PUBLIC WORKS COMMISSION
CITY AND COUNTY OF SAN FRANCISCO

Correspondence Log

Public Comment on Driveway Construction

87171	L- 6964.1 and L- 19689.1 Ch 3	Driveway Construction
-------	--	--------------------------

[Item 2]: A screenshot of SFPDW Standard Plan drawing 87171 for Driveway Construction

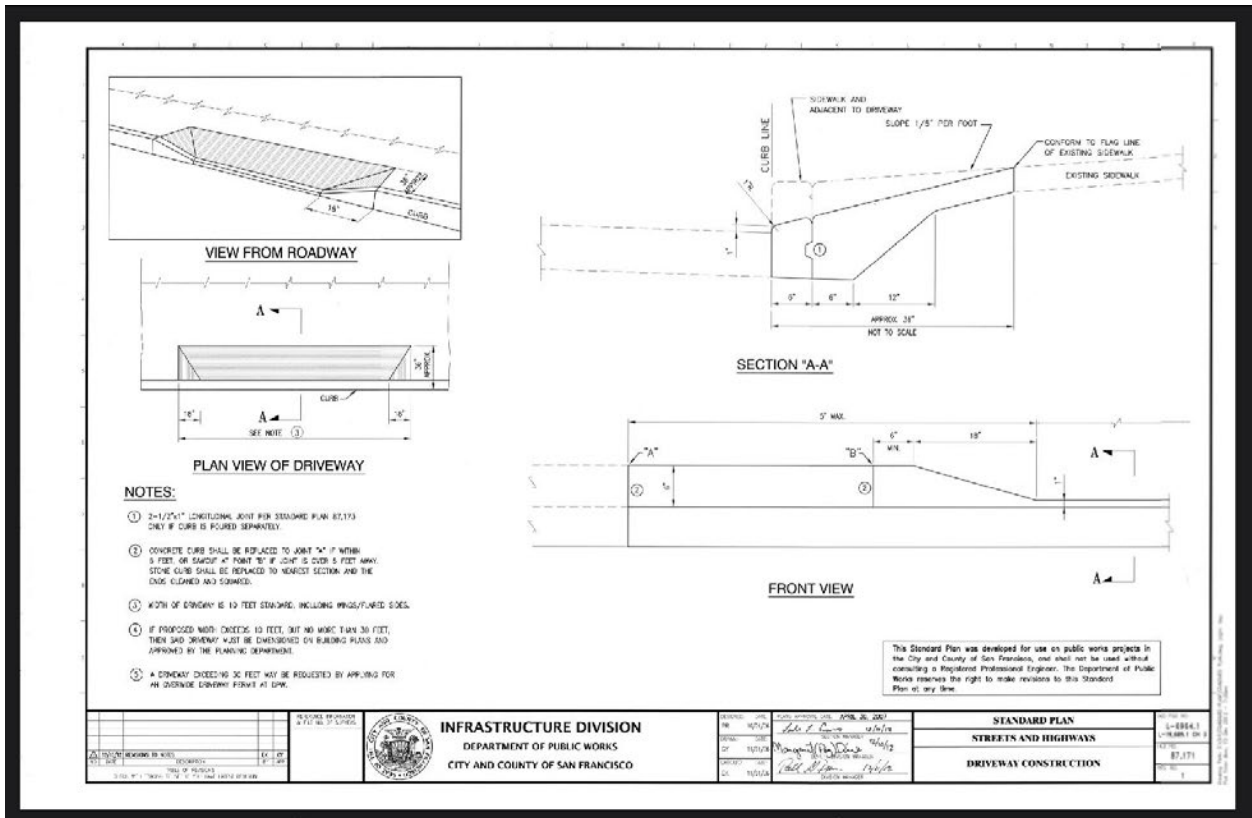
I first came to the commission [in April](#) to discuss driveway curb lips. I showed the drawings of the current [standard plan](#) from the SF department of public works' contractor resources, and made clear that the one-inch specification as it exists presents dangerous challenges for those who travel by skateboard.

Through my research I found SFPD's [Curb Ramp Program](#), which adds and updates curb ramps as part of new construction projects. This is great to see, and I'm heartened by the department's commitment to accessibility. This brings me to my ask today, which is that this commission work to amend the ordinance that created the Curb Ramp Program to include the updating of all driveways to meet the [ADA's 303 standard](#).

[Item 3]: A detail of SFPDW Standard Plan drawing 87171 for Driveway Construction

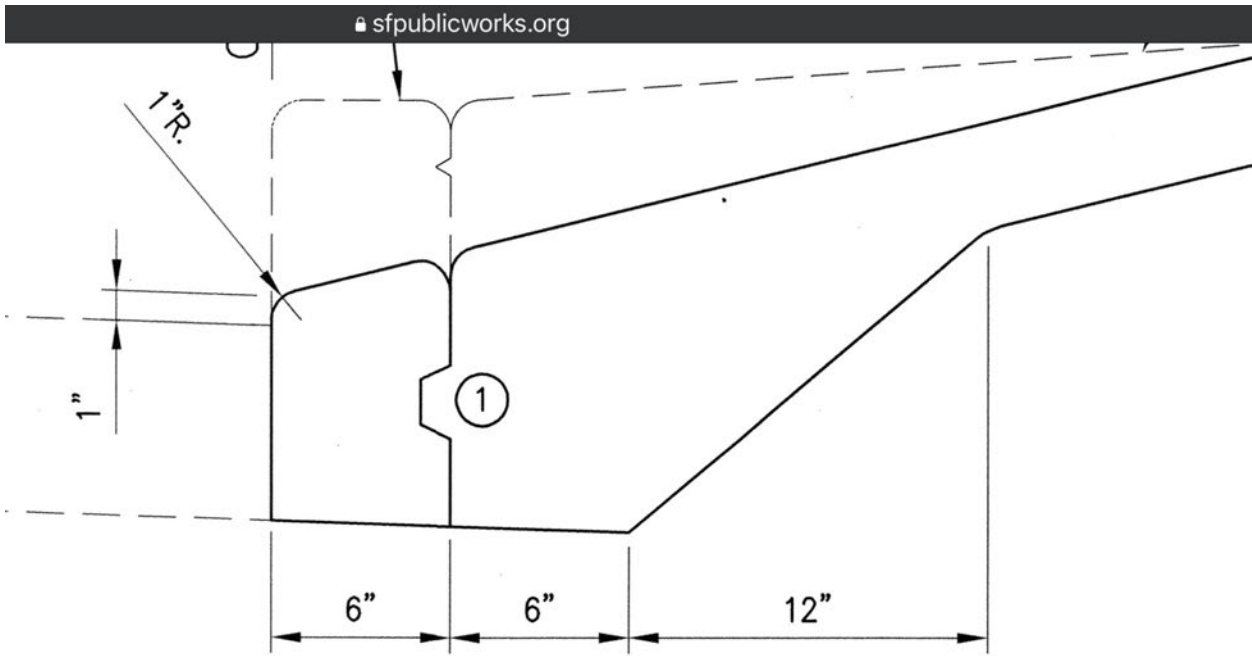
The driveway examples above do not meet either standard.
